TOWN OF EXETER, NEW HAMPSHIRE

**TOWN OF EXETER
PLANNING DEPARTMENT MEMORANDUM**

Re: Definitive Subdivision Submittal for 100 Linden Street
WAIVER REQUEST

Town Planner Comments

Sheet 5 of 10 Grading Plan

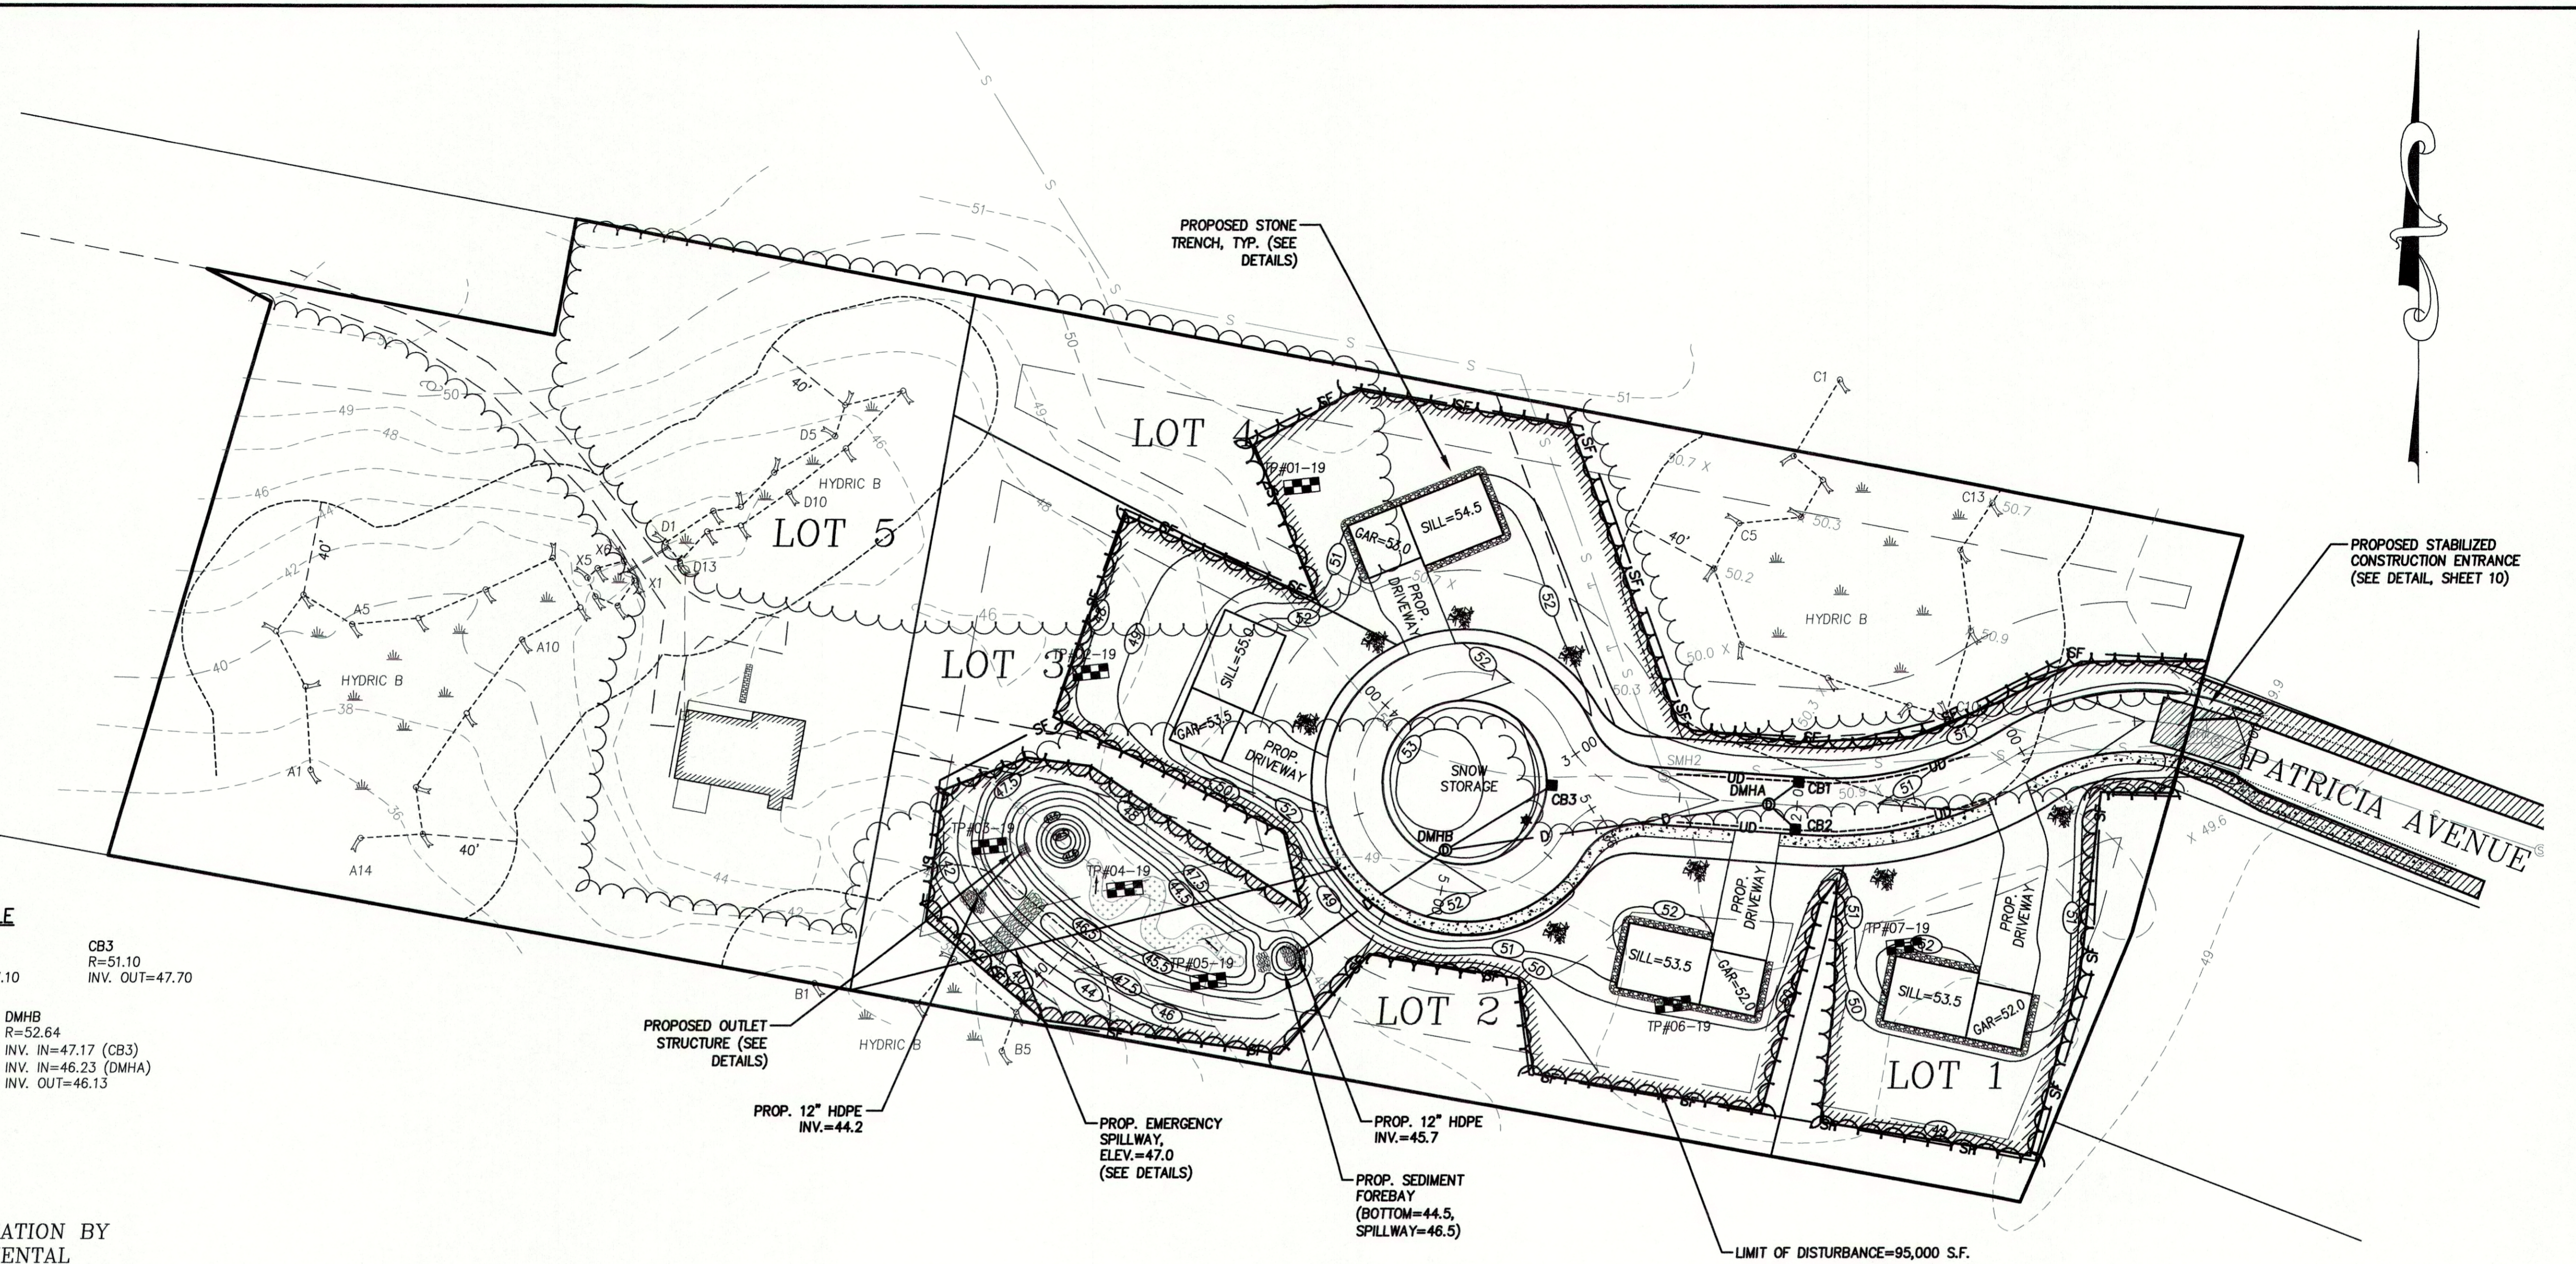
13. *Please provide a sketch showing the limits of disturbance used to determine if an Alteration of Terrain permit is required which should include all offsite improvements.*

14. *Show existing treeline. Coordinate the silt fence location with the proposed treeline.*

5. **Drain Inverts:** *Drain inverts should be added to the grading plan to facilitate review.*

6. **Detention Pond:** *The following comments pertain to the Detention Pond shown on the Grading Plan:*

- **WQV:** The Applicant should provide Water Quality Volume (WQV) calculations for the detention basin.
- **ESHWT:** The estimated seasonal highwater table (El. = 44.5') is above the base elevation of the detention pond (El. = 44.0'). The detention pond should have no standing water between storms with the exception of the micropool. The base elevation should be raised higher than the ESHWT.
- **Sediment Forebay:** The spillway elevation for the sediment forebay is noted at 46.0'. The invert for the 12" drain pipe discharging to the forebay is at 45.0'. This will cause the drain system to surcharge past DMHB. The spillway elevation should be modified to be below the outlet elevation of the proposed drainage system.
- **Micropool Access:** The detention pond should be graded to provide maintenance access to the micropool.

7. **Edge of Property Grading:** The Applicant shows grading within 5' of the edge of property line near the detention pond which is against Town regulations. Modifications to the grading or a waiver is necessary.

Response: The limit of disturbance has been added to the plan (see sheet 5).

Response: The existing treeline is shown on the plan. The silt fence has been revised to follow the proposed treeline.

Response: An invert table has been added to the plan (see sheet 5).

Response: Refer to the attached BMP worksheet in the Stormwater Report, Appendix E for the WQV calculations. The basin bottom has been raised above the ESHWT. The inlet into the sediment forebay has been raised from 45.0 to 45.7. The HydroCAD calculations show the drain system will not be adversely affected by the invert elevation into the forebay. Access to the micropool is provided via the 8-foot wide berm.

Response: The grading has been revised to tie into the existing contours outside of the 5' property line buffer.

Sheet 6 of 10 Roadway and Utility Profile

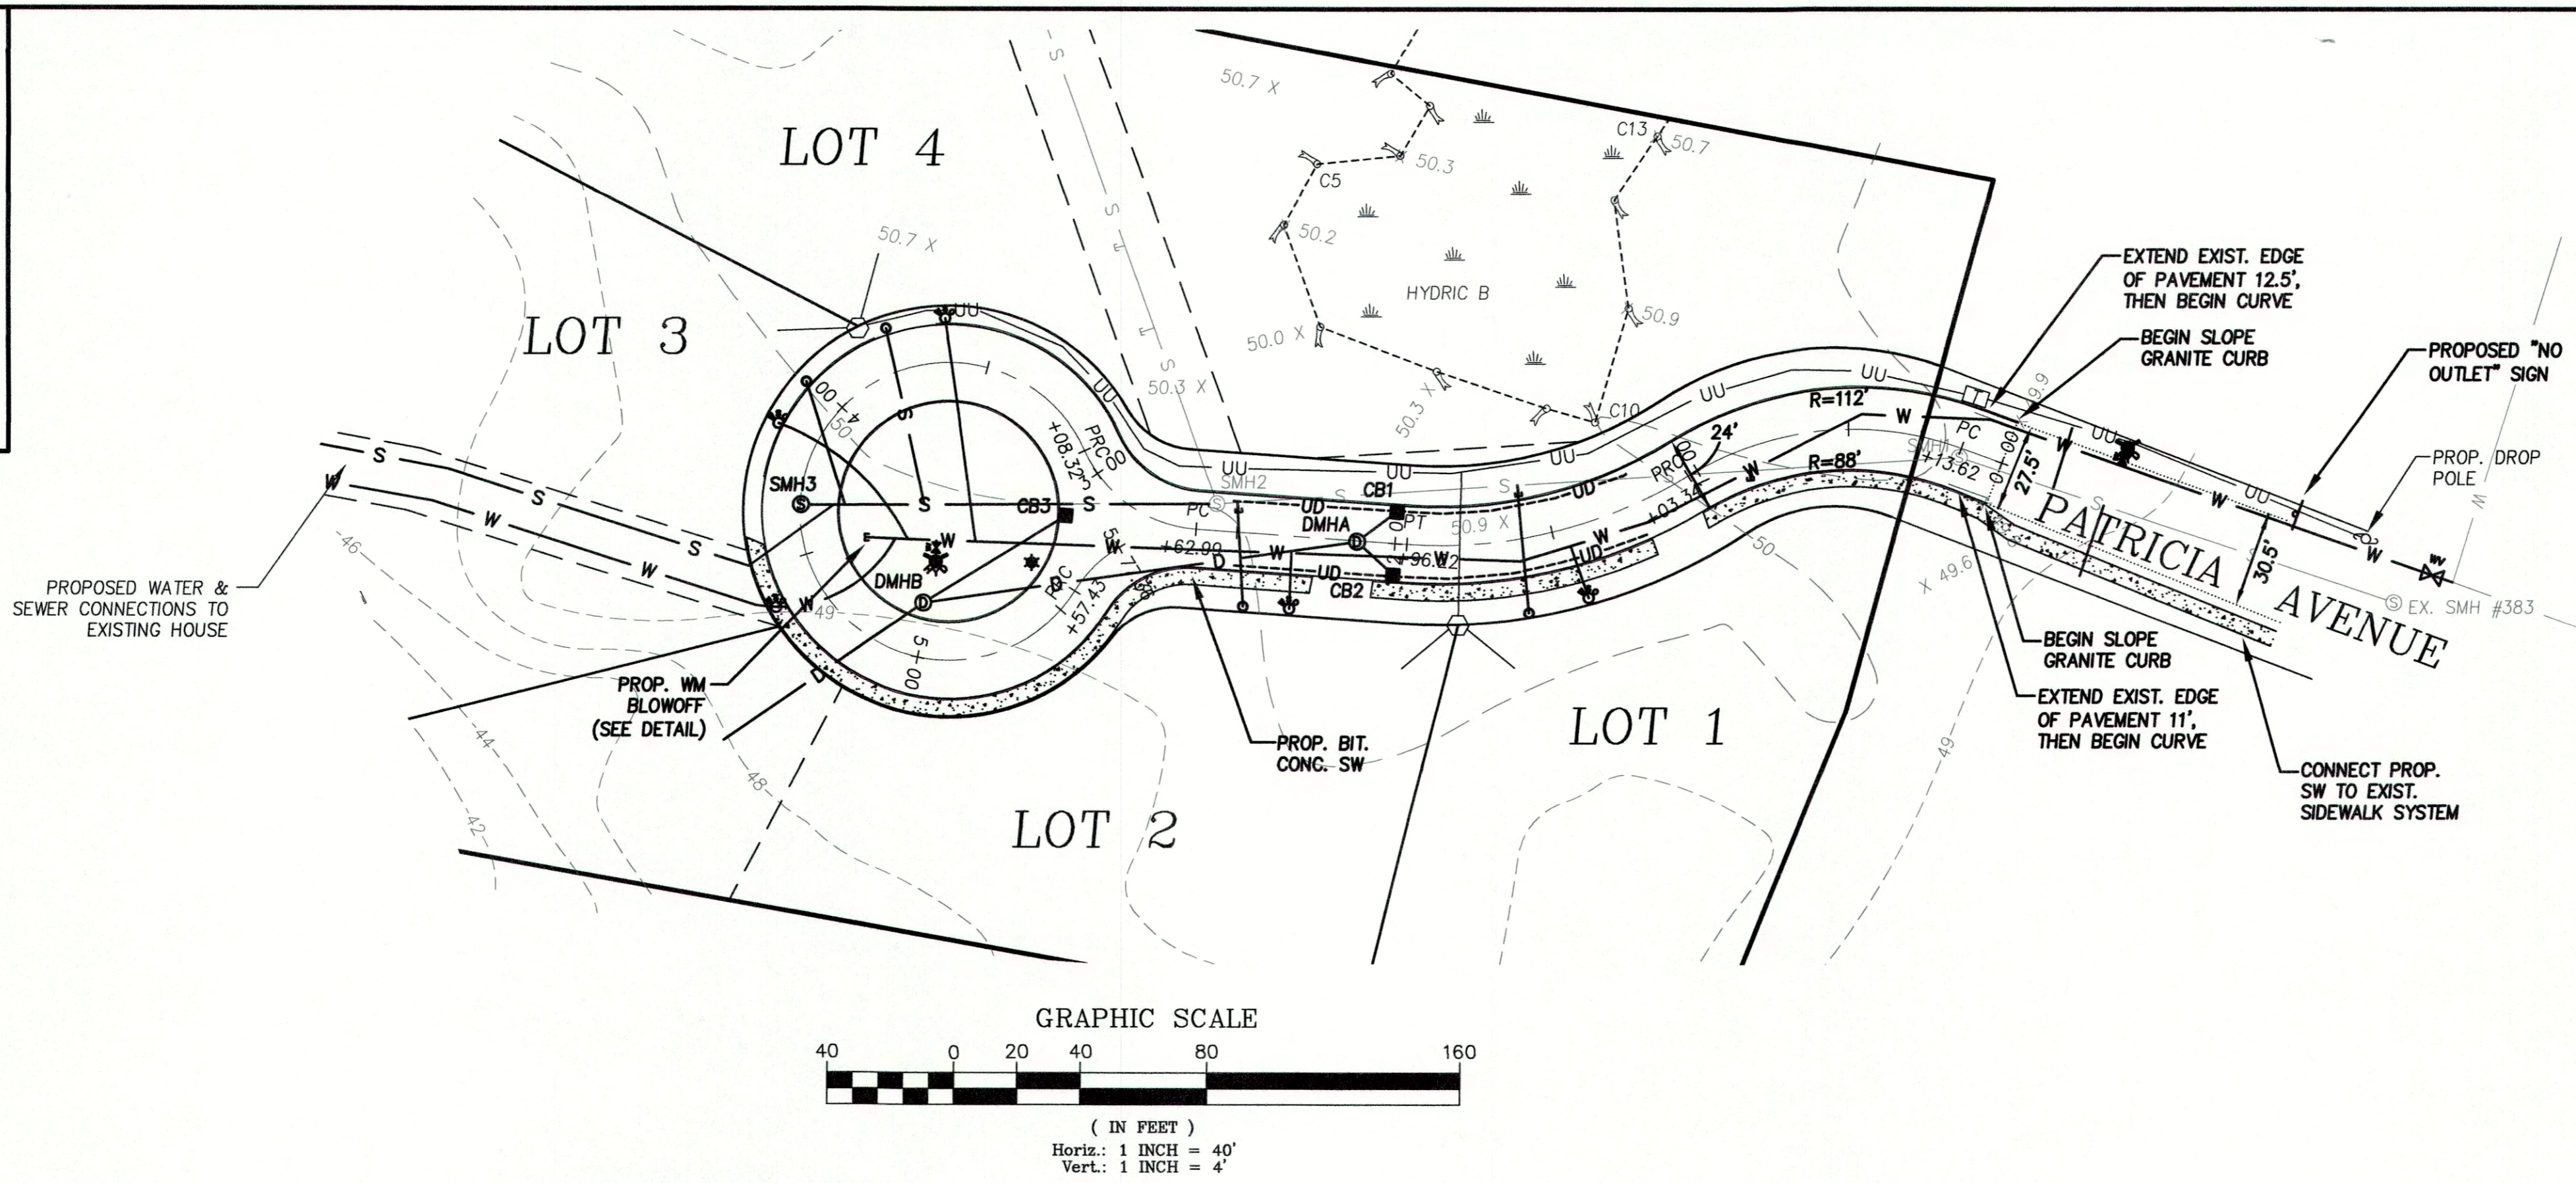
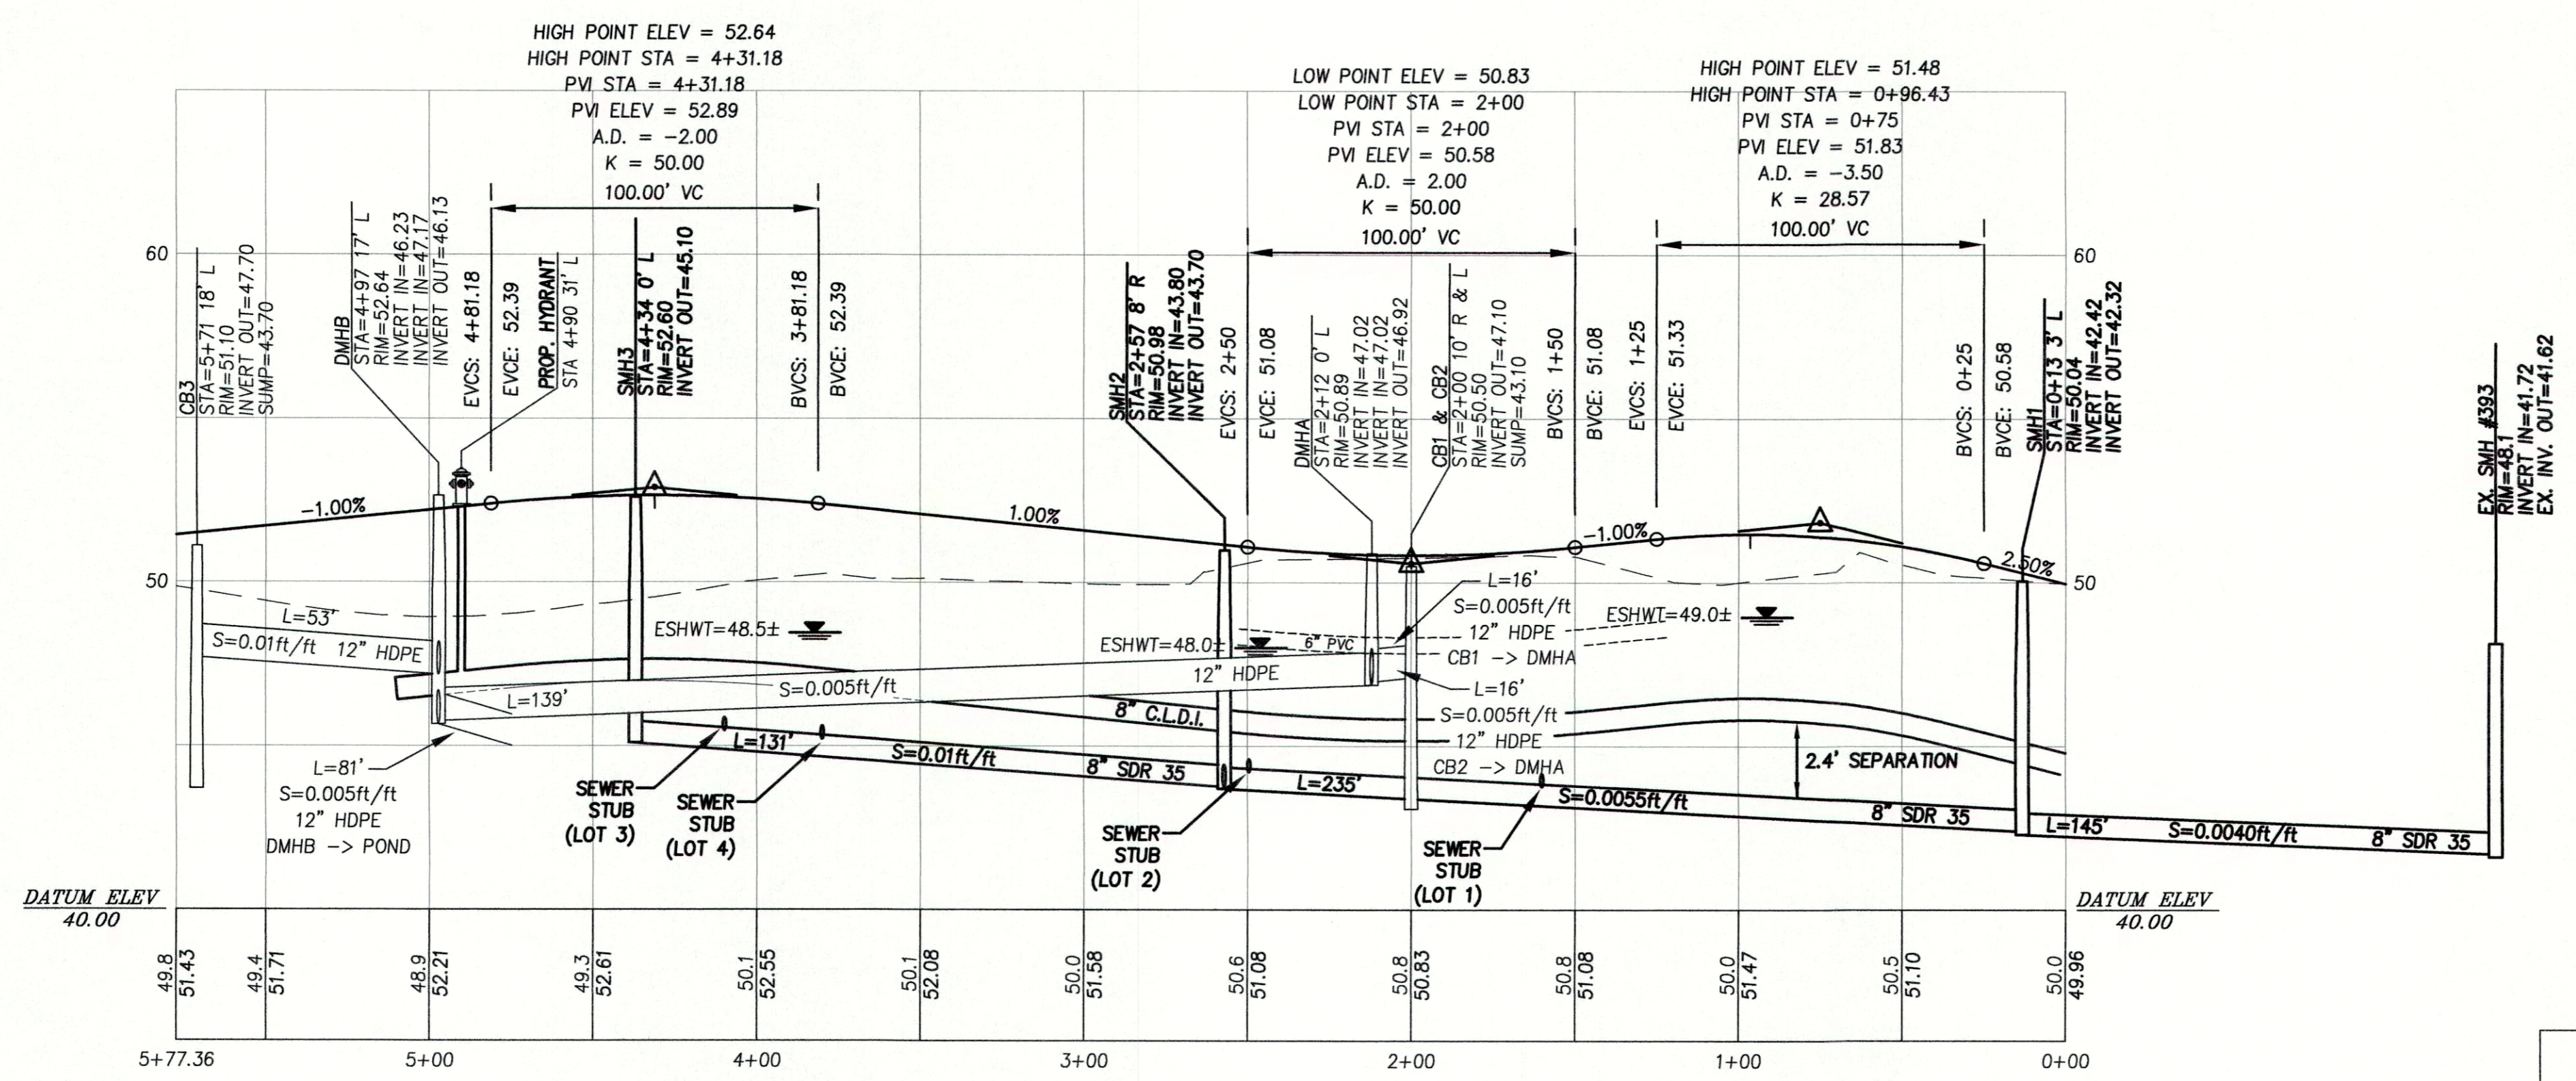
17. *Show the estimated seasonal high water table (ESHWT) elevations on the profile. The road should be designed so that the gravels are not within the ESHWT.*

20. *The "proposed street sign" is not needed in the location shown if the street name will remain Patricia Avenue. The "No Outlet" sign should be at the intersection with Thelma Drive. Remove "Dead End" sign note.*

24. *Show the location of the proposed transformer and telephone pedestal, which should be outside of the ROW. Coordinate with Unitil for drop pole location. Gas and electric layouts approved by Unitil are required for the final plans.*

10. Existing Sewer: *The sewer shown on the plans appears to be proposed with its bold line weight. The sewer has already been built and should be identified as an existing utility. The proposed sewer services should be shown bold and the method of connecting to the existing sewer main should be identified.*

11. Underground Utilities: *Each utility should be shown on the Utilities Sheet to avoid installation conflicts during construction. See Comment 3 above.*

15. Street Lighting: *Proposed street lighting should be shown on the Roadway and Utilities Profile Sheet. Proposed lighting shall be dark sky compliant.*

Response: The ESHWT elevations have been added to the profile. Please note, no test pits were performed within the proposed roadway so water tables are approximate. Other than test pits #02-19 and #03-19, which are located further downslope and in poorly drained soils, the average ESHWT on the site is approximately 21 inches. The majority of the proposed roadway is constructed in fill, so we don't foresee any major issues

with the gravel intercepting the ESHWT. However, we have added subdrains from station 1+25 to station 2+50 where it is most likely the gravels may intercept the ESHWT.

Response: The proposed "No outlet" sign has been moved to the intersection with Thelma Drive. The proposed street sign has been removed.

Response: Approximate locations of the drop pole, transformers and hand holes have been added to the plan (see sheet 6). We understand that final locations of the electric layout will be provided by Unitil.

Response: The sewer has been revised to depict it as existing. Proposed sewer services are shown in bold and a sewer service detail is shown on sheet 9.

Response: The plan has been revised to show an underground utilities line, which encompasses electric, telephone, and cable.

Response: Per the Exeter Public Works, we have added a street light at the cul-de-sac.
